**APPLICATION FOR PERMISSION  
UNDER SECTION 16 OF  
THE TOWN PLANNING ORDINANCE  
(CAP. 131)**

For Official Use Only 請勿填寫此欄	Application No. 申請編號	A/NE-FTA/269
	Date Received 收到日期	12 SEP 2025

# Proposed Temporary Open Storage of Construction Machinery and Construction Materials and Associated Filling of Land for a Period of 3 Years

Lots 333 RP (Part) & 334 (Part) in D.D.87, Ta Kwu Ling, N.T.

Title:  
Drainage Proposal - LAYOUT

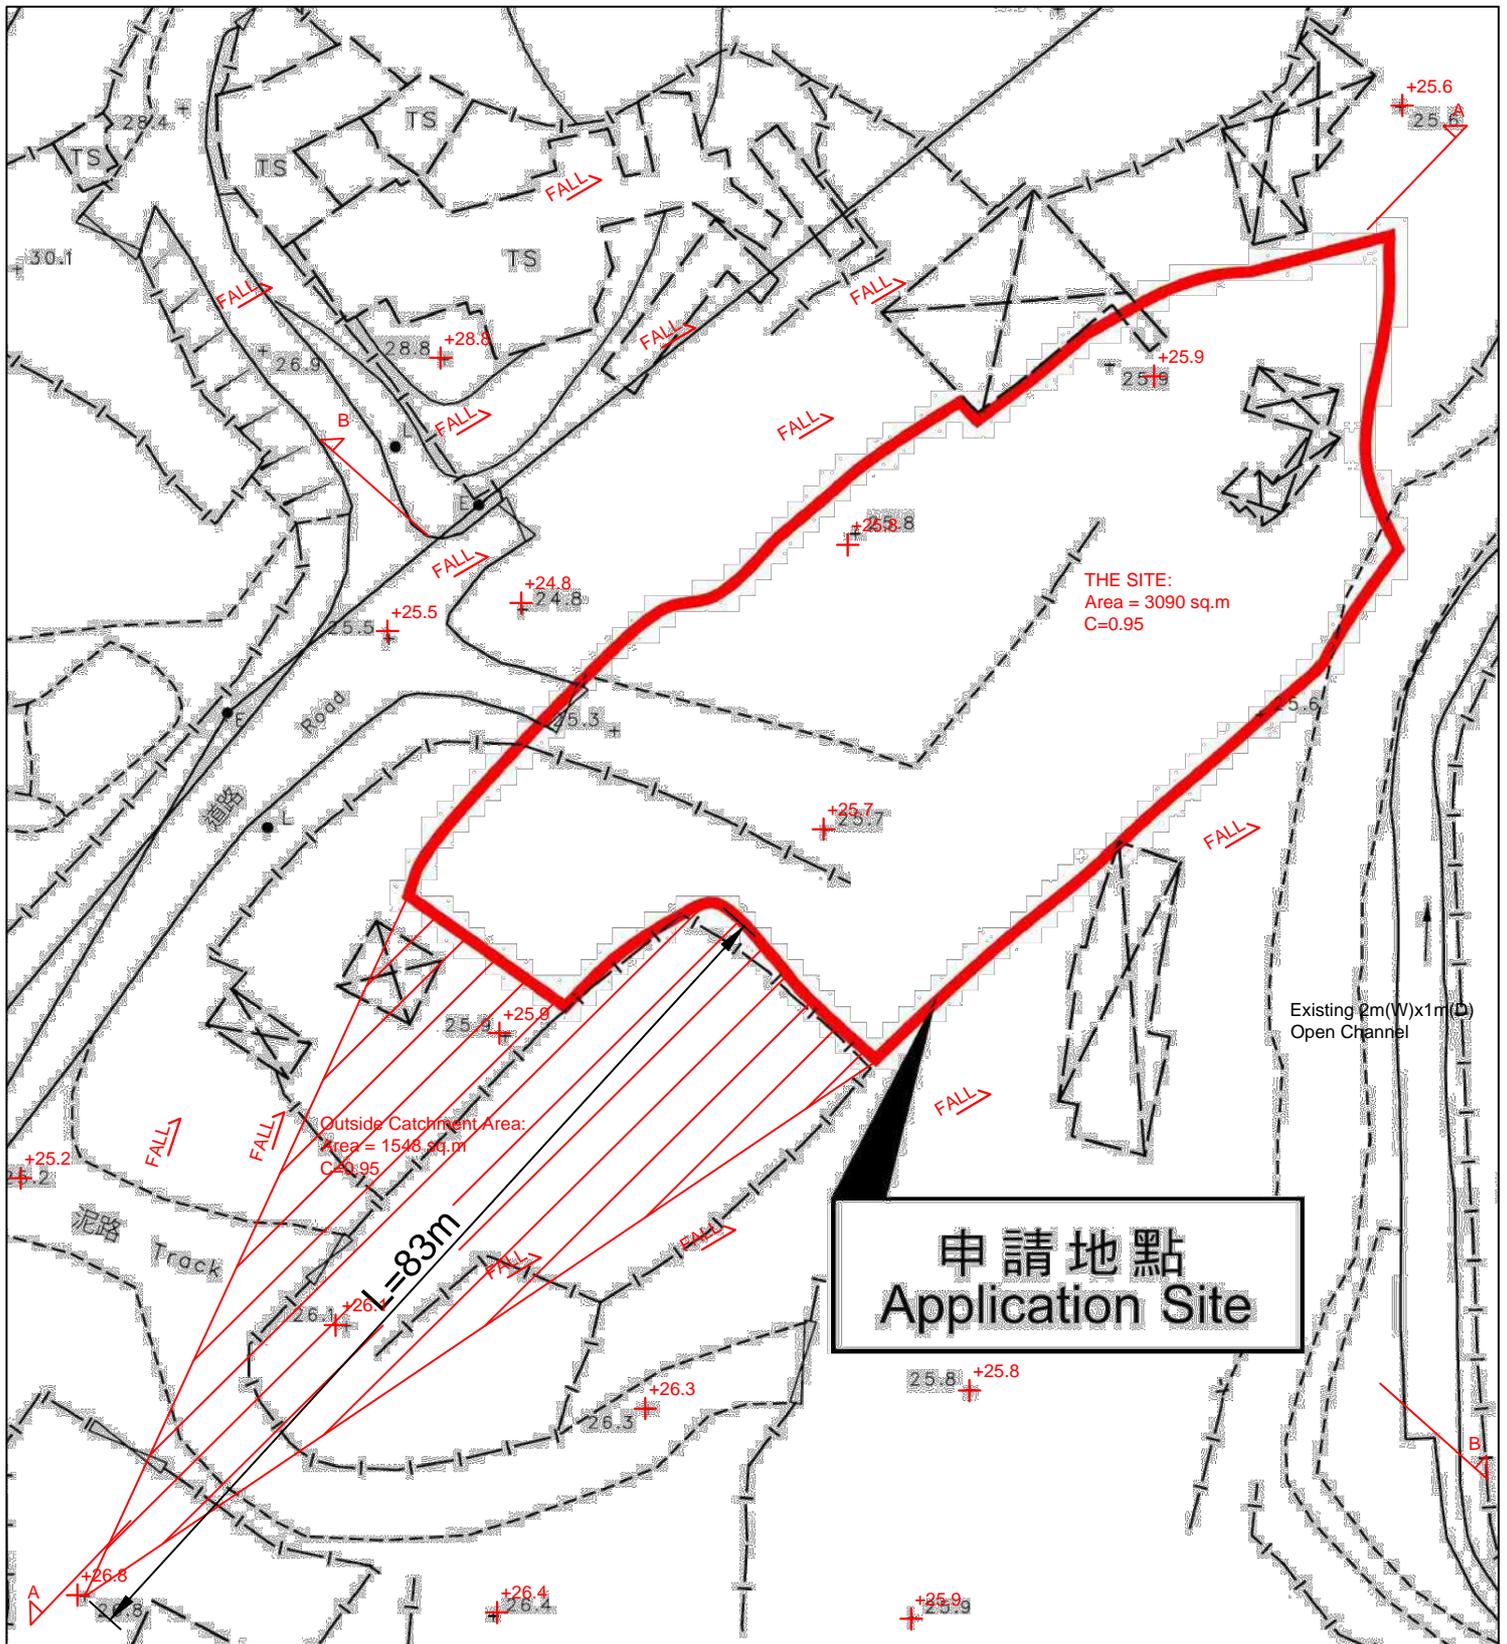
(e) A drainage plan should be provided clearly showing the size, levels and routes of the proposed drainage. The details (invert level, gradient, general sections etc.) of the proposed drain/ surface channel, catchpits and the discharge structure shall be provided.

**A drainage plan with all the details are provided.**

**Photo 1**

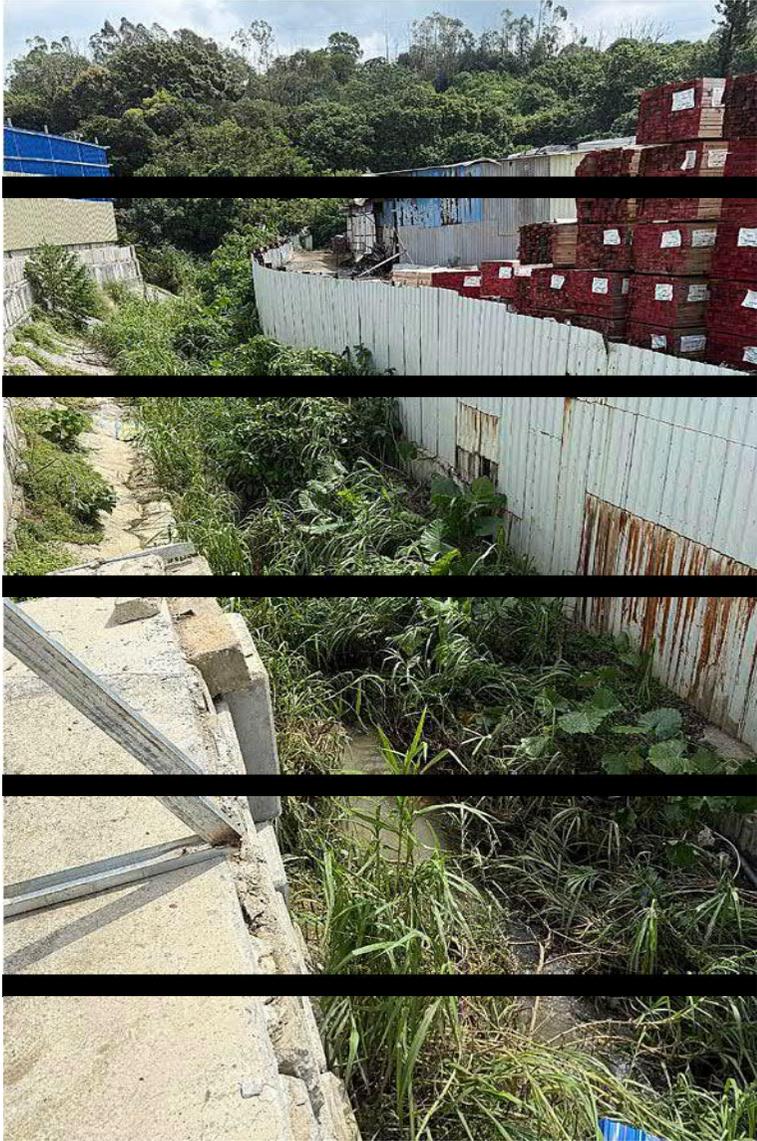
(o) Photos should be submitted clearly showing the current conditions of the area around the site, the existing drainage/flowpaths around the site, the proposed drainage from the site to the downstream existing watercourse and the existing watercourse at about 20m intervals. The locations of the camera and the direction of each photo should also be indicated on a plan.

**Photo is provided.**
